Re: Bond Release No. 12 for Permit BNLS-8109

This submittal contains a response to your letter to us dated June 9, 2009. In this letter you listed technical deficiencies that must be addressed before the bond release can be approved. Enclosed, please find three copies of instructions and the updated items to address the deficiencies. A complete copy of all notification letters is also enclosed.

4 RC-09-64 Filed 07/13/2009 Pages: 7  
Response to Deficiency Letter Filed by BNI Coal  
BNI Coal, Ltd.  
Jay Volk

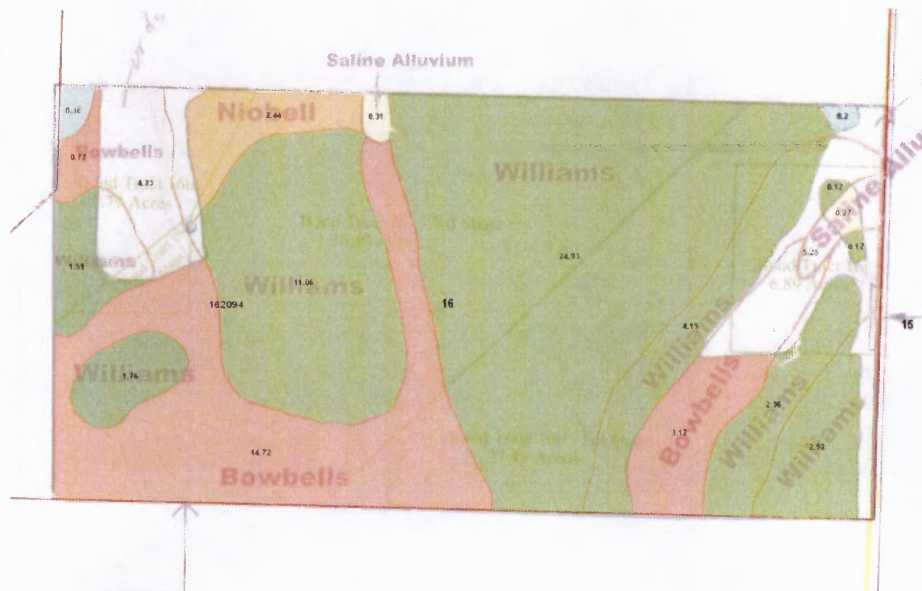
18. According to the Attachments V and VII only approximately 2.8 acres of Niobell Loam soil was disturbed, but the standards in Tables 2, 3 and 4 were computed using 6.0 acres of this soil mapping unit. It appears the pre-mine soil acreage difference should be applied to the Bowbells soil mapping unit as our calculations show there were approximately 18.5 acres of Bowbells in the pre-mine cropland. Also, the acreage of the pre-mine soils in the area occupied by the embankment for Pond 9 should not be used in these calculations. Please review and correct Tables 2, 3, and 4 as necessary. An image showing the acres of each mapping unit is shown below. (GAW)

*The soil standard was revised as requested and tables 1,2,3, 4, and the associated narrative was updated as necessary. Acres of each soil series was also included on Attachment VII as well as labeling the undisturbed areas.*
